SAFENIGHT TECHNOLOGY INC.

March 13, 1995

As a point of reference, Sleepsafe Corporation was re-named SafeNight Technology Inc. in November 1994. In response to your letter dated February 9, 1995 and our conversation afterward, we can offer the following comments/elaborations at this time:

FIGURE 1

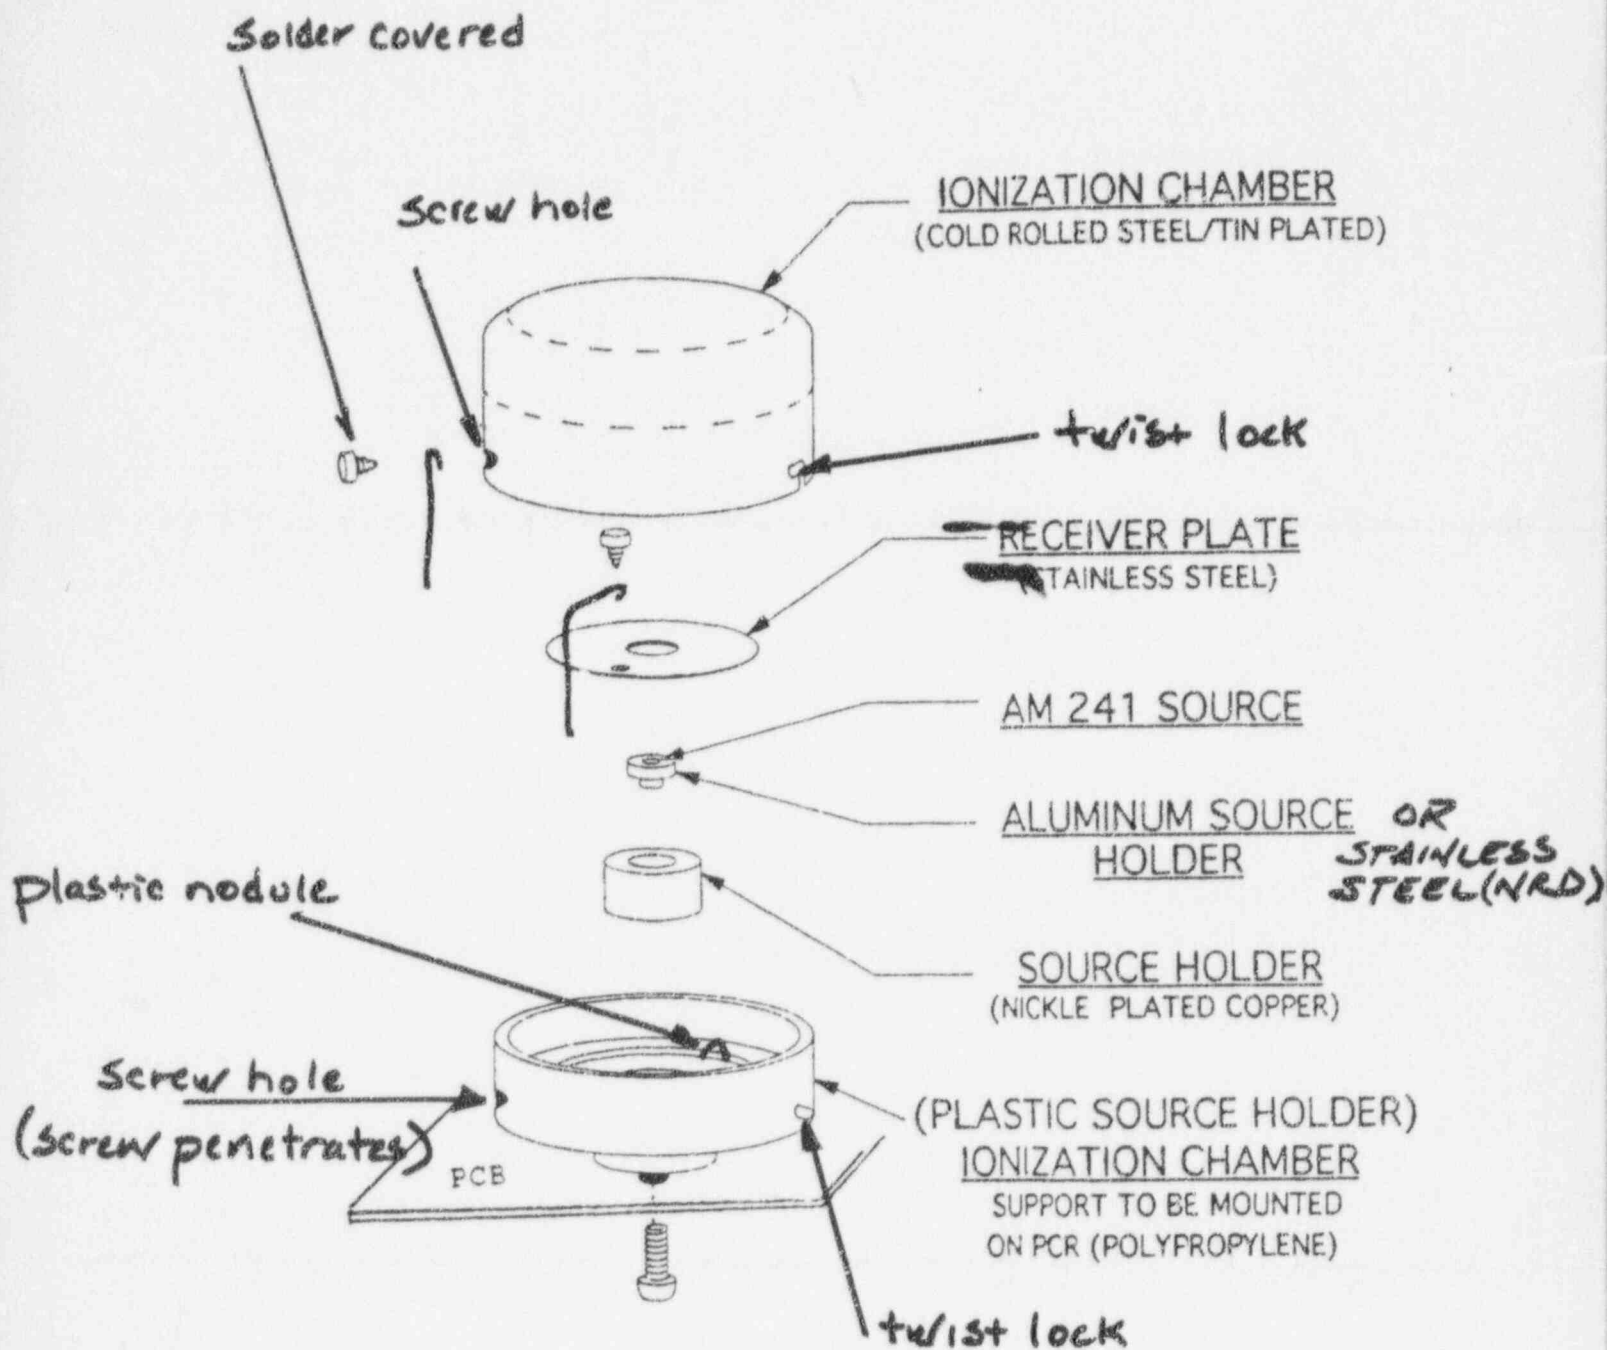
- 3) Ionization chamber security. Please refer to Figure 1 (another copy attached). The nickel plated copper source holder is built with a female plug in the bottom of it. The aluminum source holder (stainless steel - NRD) is crimped into the nickel plated source holder. Both are then placed inside a snug-fitting plastic source holder. The receiver plate is placed on top of the source holders and held in place by a screw and a plastic nodule present on the plastic source holder. The steel tin-plated cup is then placed over the plastic source holder (again a snug fit) and twist-locked. A screw is applied that penetrates both the steel/tin cup and the plastic source holder. This screw will be covered with solder to prevent tampering. Its presence will prevent any un-twisting action of the cup short of destruction. (The chamber will be delivered from our supplier - HomeWatch at this stage)

The chamber will be placed on the PCB and screw connected from the other side. The lead wire from the receiver plate is soldered to the smoke detector chip and the other lead wire is soldered to the board. Both

will prevent the unscrewing of the chamber from the board short of destruction.
